# Access Compliance Report

## Public Rights-of-Way

### (Curb Ramps)

Intersection ID: 29992	Main Street: REIGATE_RD	Cross Street: KEMPSFORD_DR	Location: S
ADA ID: BDE69EF98C0E	Ramp Type: PerpDiag	Initial Pass/Fail: Fail	Overall Compliance: No
Severity Score: 8.75			
Codes/Mitigation Info/Possible Solution		Field Measurements/Component Compliance

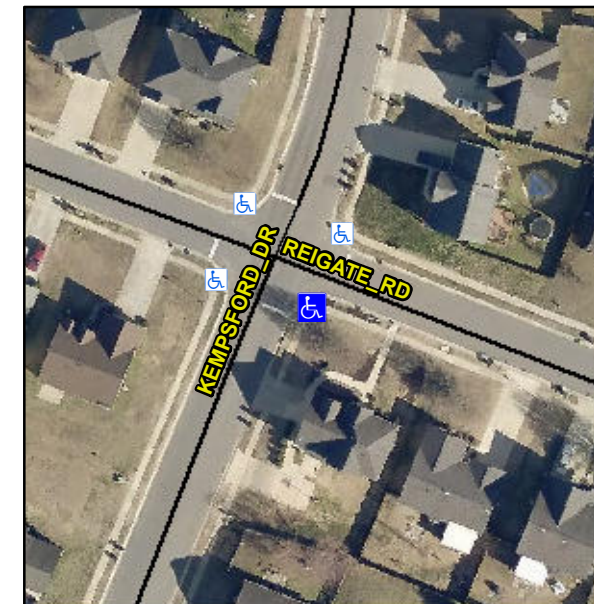
**Remove & Replace Curb Ramp With Two New Directional Ramps or Equivalent.**

**Not Found, R304.5.1**
